# MIAMI BEACH

PLANNING DEPARTMENT  
Staff Report & Recommendation

Design Review Board

SUBJECT: DRB21-0739  
**291 Palm Avenue**

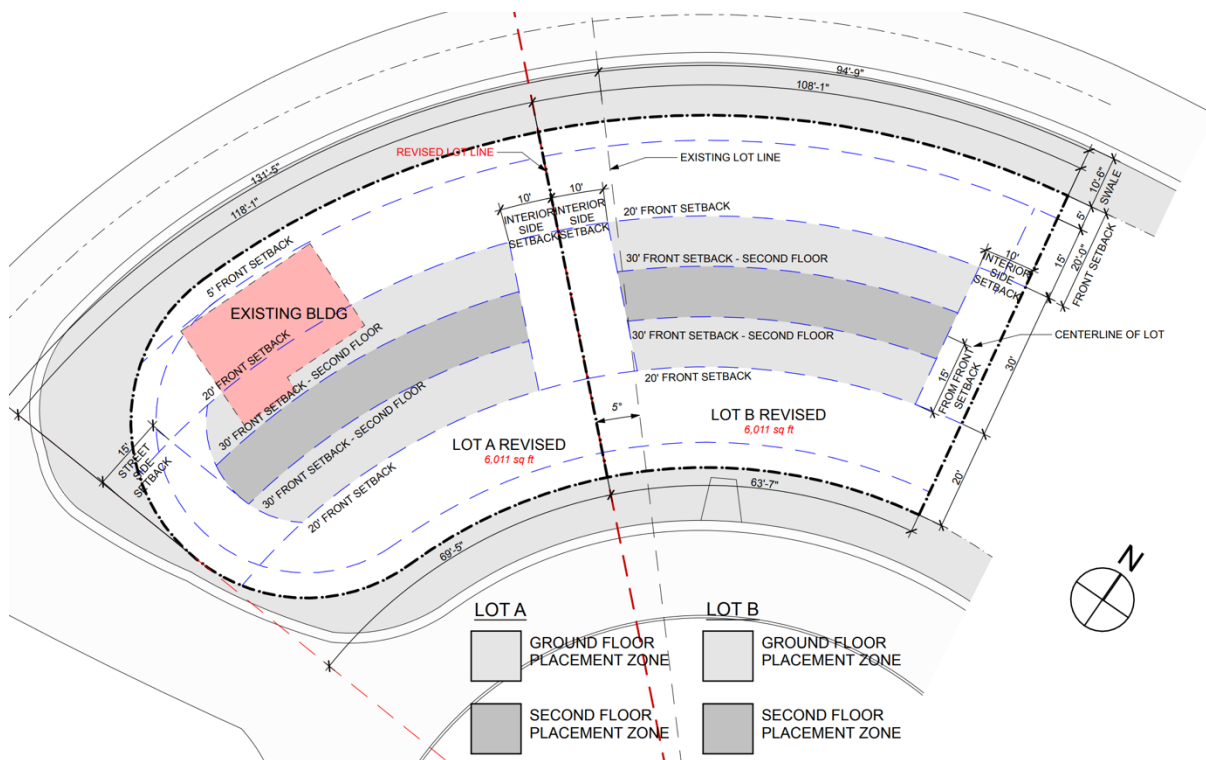
As indicated previously, this lot is rather unique in that it has a curved trapezoidal shape, with two street fronts and is also very shallow, with a lot depth of only 70 feet. Most single family lots on Miami Beach have a lot depth of at least 100 feet. The diagram below shows that absent any relief from the City code, with the current required setbacks, the maximum width of a single-story home is 30 feet, and the maximum width for a 2-story home is only 10 feet. This shallow lot depth, as well as the unique bean shape of the lot, does present a hardship for the construction of any home on the subject site.

With the reduction in unit size, from the previous request of 50% down to 45% - **Variance #2)** and the reduction in lot coverage from the previous request of 31.2% down to 30% - **Variance #1)**, staff is now supportive of these variances, which are now consistent with our prior recommendation.
